RE: Robb House Restoration, 66 Monique Court, Town of Markham

Re: Independent Engineering Inspection of Damage to a Relocated

## EXTRACT CONTAINING ITEM # 3 OF THE THIRD HERITAGE MARKHAM COMMITTEE MEETING HELD ON MARCH 12, 2008

3. SITE PLAN APPROVAL APPLICATION REPAIR OF DAMAGE TO THE ROBB HOUSE FILE NO. SC 06 134969 66 MONIQUE COURT (16.11)

## FIGURE 3:

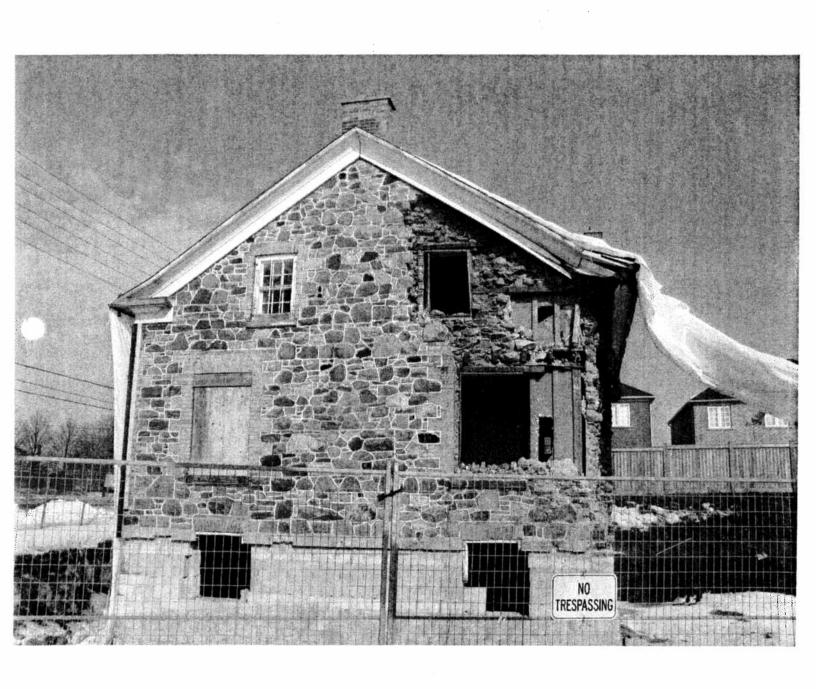
Robb House, damage to front wall following relocation. (2007 photo)

Robb House, damage to south east corner, recent condition. (2008 photo)

## ROBB HOUSE - RE-CONSTRUCTION MARCH 2008

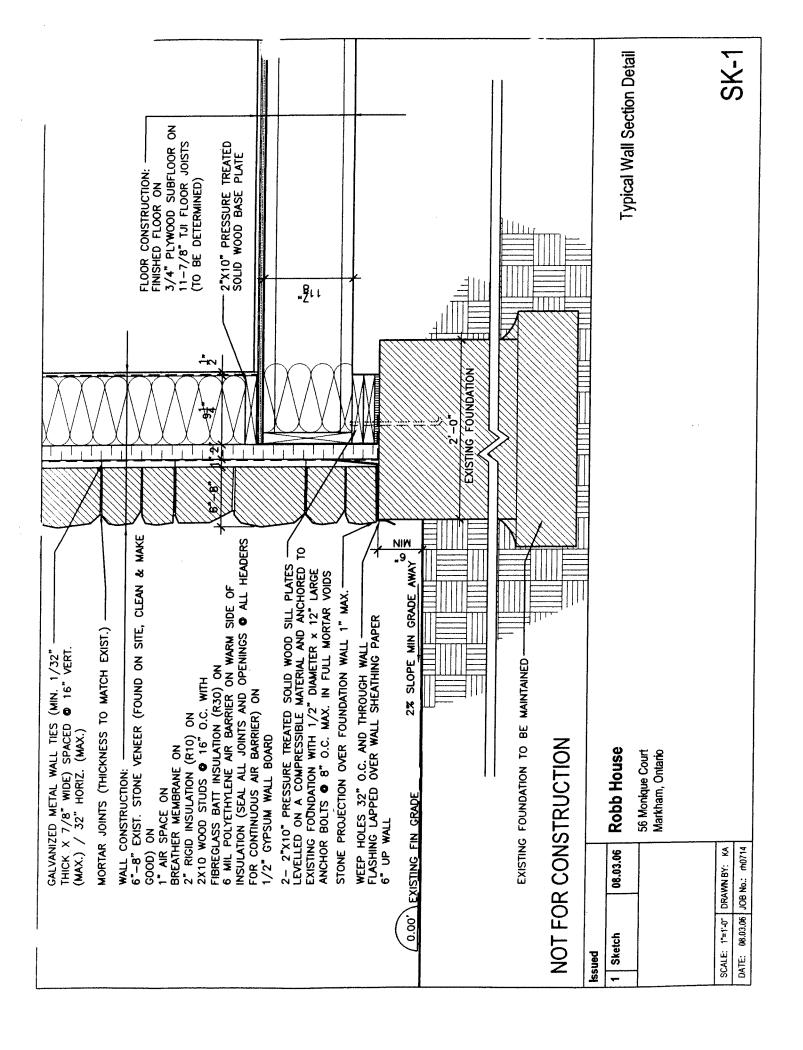
- 1. Take physical dimension of all elevations establishing location of all windows, doors and heights
- 2. Remove front cut stone lintels particularly the date engraved one
- 3. Salvage as many sill as possible
- 4. Remove exterior stone walls
- 5. Separate the exterior faced stone from the interior back-up rubble, creating a supply
- 6. Create a supply pile of larger interior rubble stone for possible use
- Remove fireplace mantels if possible
- 8. Remove the balance of the old structures
- 9. Rebuild house using 2x10 studs, exterior insulation and 2x12 joists
- 10. Frame roof to original pitch having regard for original photos available
- 11. Provide fieldstone veneer
- 12. All windows to be of wood single hung construction
- 13. All trim to be of wood construction
- 14. Shingled roof

THAT Heritage Markham accept the opinion of Rochon Engineering Incorporated, and acknowledge that given the state of the Robb House, the option of creating a replica using some of the original material can be supported subject to the applicant providing details of how much of original material will be salvaged, and how this can be accomplished safely;

AND THAT the applicant amend his site plan agreement to reflect the revised plan to replicate the building, with detailed drawings and specifications to enable an accurate replication of the form and features (brick details around windows, quoining, eave returns, etc.) and enter into the site plan agreement with an appropriate Letter of Credit attached to it:
